4100 JONES BRIDGE ROAD
 PARCEL 976
 HAYES
 PROPOSED FIVE LOT SUBDIVISION (A-E)
 PRELIMINARY PLAN

Re: **CAS Job No. 16-176**
4100 Jones Bridge Road, Chevy Chase, MD 20815
Parcel 976, Hayes, Tax Map HP341 & HN343
Preliminary Plan #: 120170180
Forest Conservation (Chapter 22A) Variance Request - Revised

RE: Preliminary Plan No. 120170180
Hayes

Re: Combination Stormwater Management
Concept/Site development Plan Request for
4100 Jones Bridge Road
Preliminary Plan #: N/A
SM File #: 282523
Tract Size/Zone: 2.1/R-90
Total Concept Area: 2.1ac
Lots/Block: 5 Proposed
Parcel(s): P976
Watershed: Rock Creek

PRELIMINARY PLAN NO. 120170180
4100 JONES BRIDGE ROAD
PARCEL 976
HAYES
PROPOSED FIVE LOT SUBDIVISION (A-E)
FIRE DEPARTMENT ACCESS PLAN

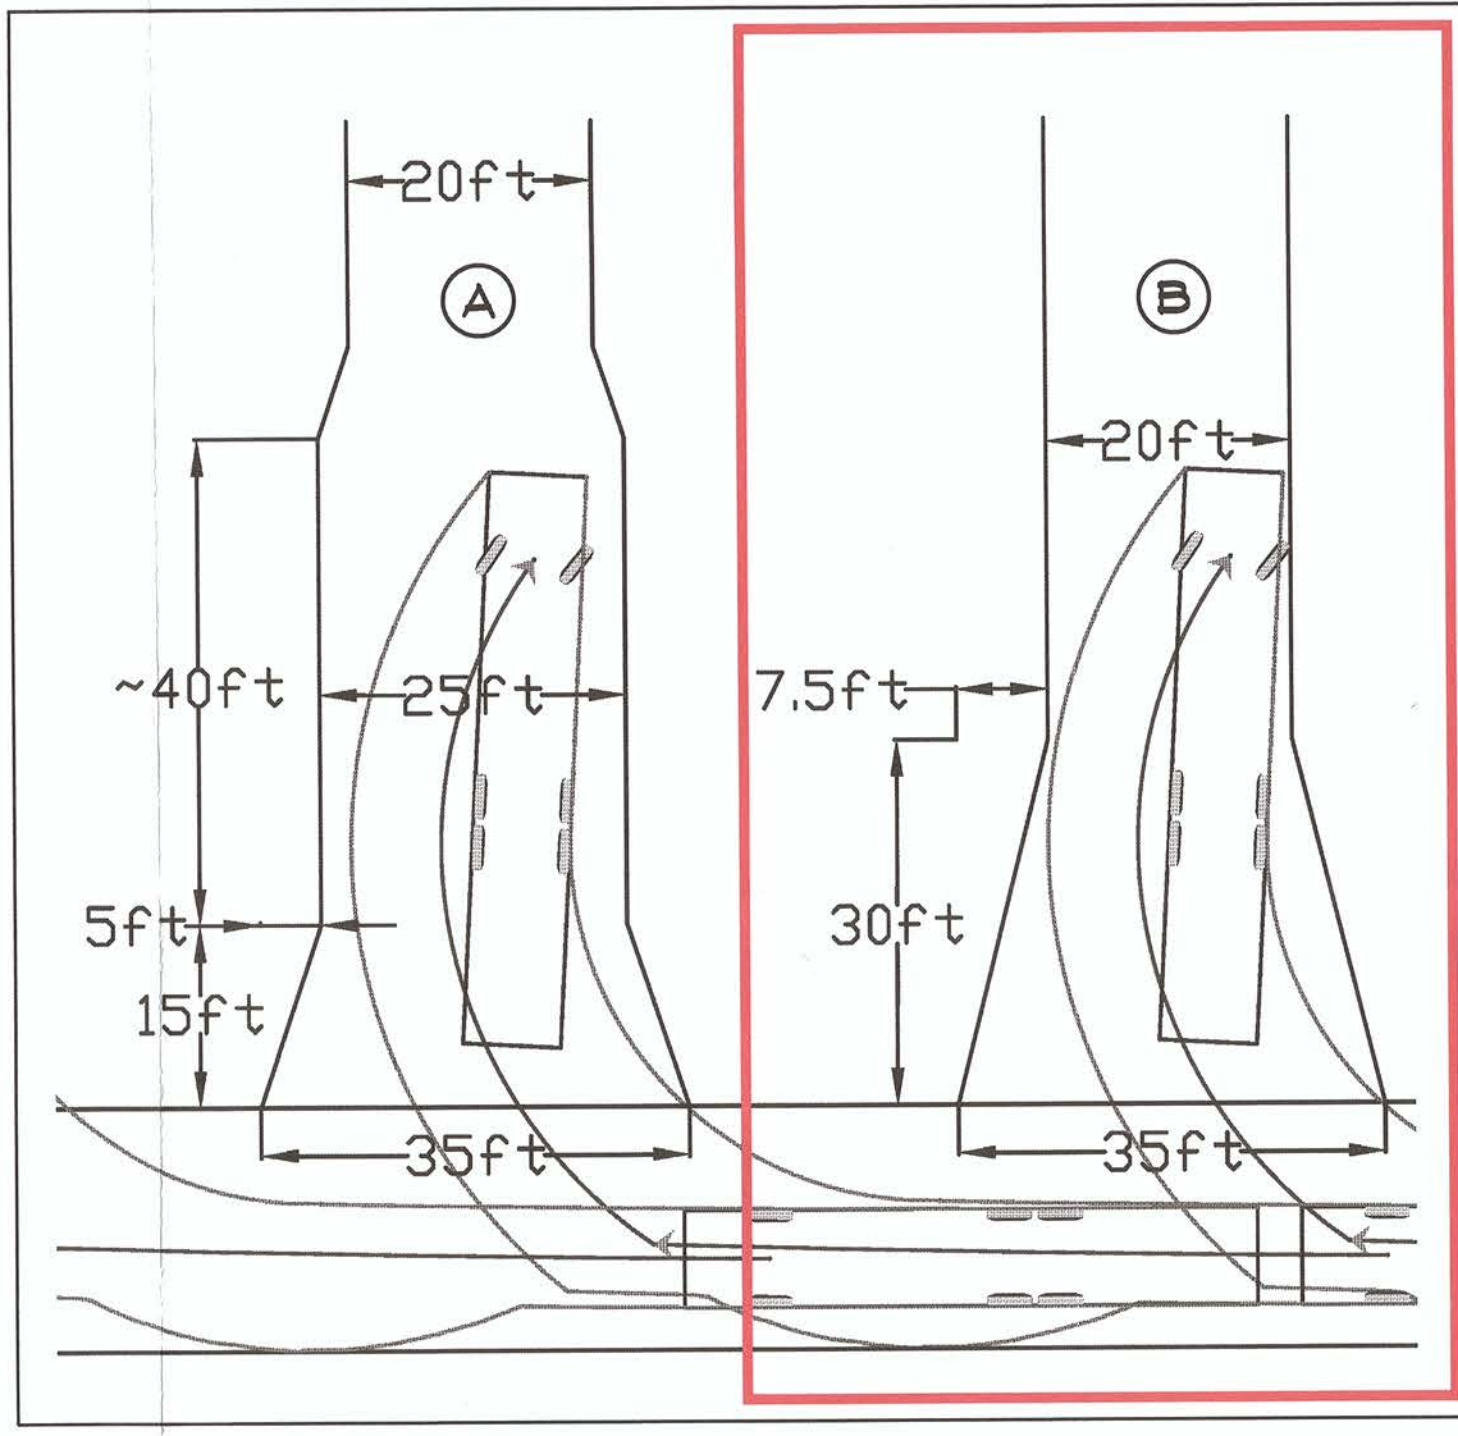
FIRE DEPARTMENT ACCESS ROAD MUST BE CAPABLE OF SUPPORTING 85,000 LBS.
NO PERMEABLE PAVEMENT INSIDE BOUNDS OF FIRE DEPARTMENT VEHICULAR ACCESS
